Access Compliance Report

Public Rights-of-Way

| Intersection ID: 22863 | Main Street: ARBOR_RIDGE_DR | Cross Street: CEDAR_CROSSINGS_DR | Location: SW |
| ADA ID: 9B73BB99AB51 | Ramp Type: PerpDiag | Initial Pass/Fail: Pass | Overall Compliance: No |

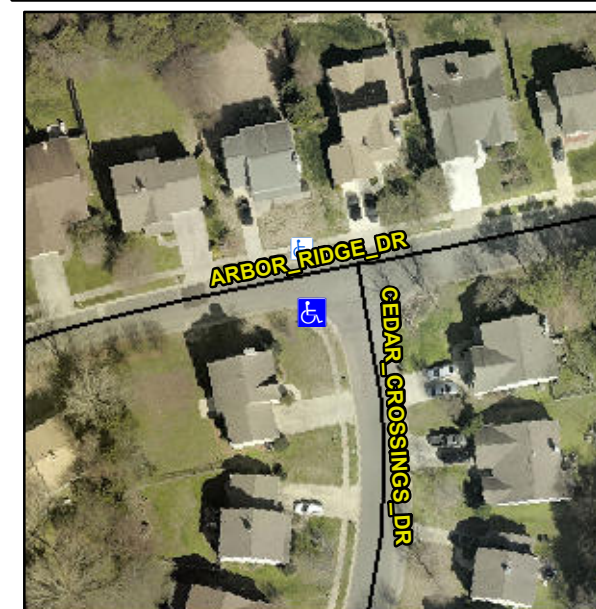
| Severity Score: 20 | | | |

Not Found, R304.2.1, R304.2.2-Perp, R304.3.2-Para, R304.5.3, R305

| Compliance | Description | Data | Compliance | Description | Data |
|------------|-----------------------|--------|------------|-----------------------------|------|
| No | Landing Length (in) | N/A | No | DWS Provided? | No |
| No | Landing Width (in) | N/A | N/A | DWS Contrast? | No |
| No | Landing Slope (%) | N/A | N/A | DWS Length (in) | N/A |
| No | Landing X Slope (%) | N/A | N/A | DWS Full Width? | No |

Remove & Replace Curb Ramp With Two New Directional Ramps or Equivalent.
